Barton Springs Pool

Current Schematic Plan
AIPP artwork is being proposed to be placed approximately where the "E" is. Artwork would eliminate 12-foot circular overlook pad.

Plan View

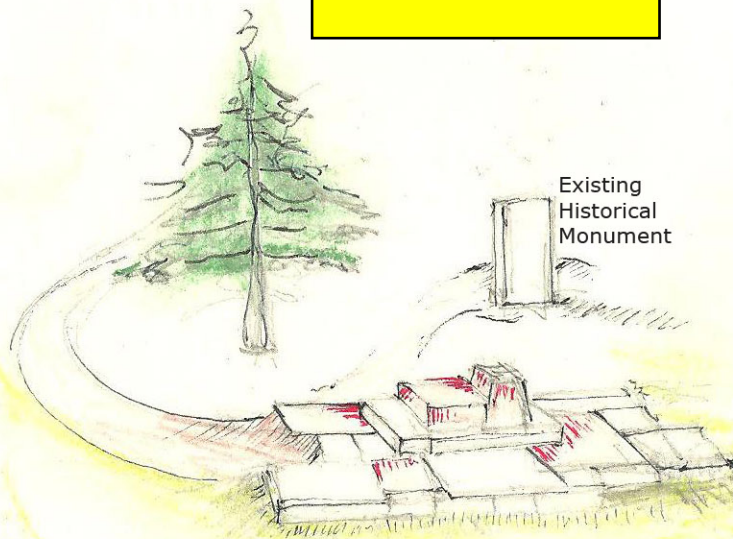
Revisions to the Plan:

1. Relocated Pathway to Area E outside Critical Root Zone of trees.
2. Reduced Diameter of Stone area at Overlook from 18' to 12 feet.
3. Relocated Bike Parking area to front on Hike and Bike Trail.
4. Modified South Entry Gate and Stone Columns.
